## **Proposal for Supplement 4 to the 07 series of amendments to UN Regulation No. 107 (M<sub>2</sub> and M<sub>3</sub> vehicles)**

### **Submitted by the experts from the Working Party on General Safety\***

## Supplement 4 to the 07 series of amendments to UN Regulation No. 107 (M<sub>2</sub> and M<sub>3</sub> vehicles)

"Figure 31

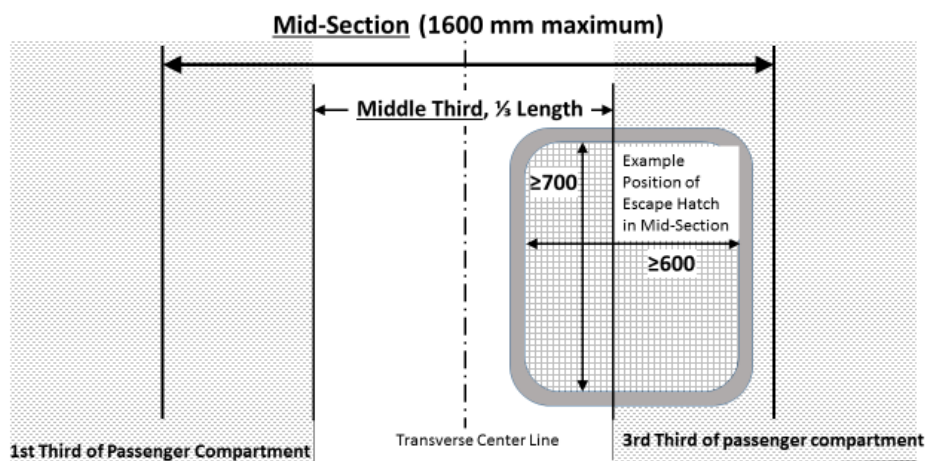
Insert a new Paragraph 7.6.2.9. to read:

- "7.6.2.9. For vehicles of classes A and B, required escape hatches shall be positioned as follows:
- If there is only one hatch, it shall be situated in the middle third of the passenger compartment. As an alternative, on vehicles with a very short passenger compartment length, the hatch may be located in the mid-section of this compartment, and this mid-section shall be equally spaced longitudinally each side of the transverse centre line of the passenger compartment, with a length of no greater than 1.6m as shown in Annex 4 Figure 31;
  - If there are two hatches, they shall be separated by a distance of at least 2 m measured between the nearest edges of the apertures in a line parallel to the longitudinal axis of the vehicle."

Annex 4, after Figure 30 insert:
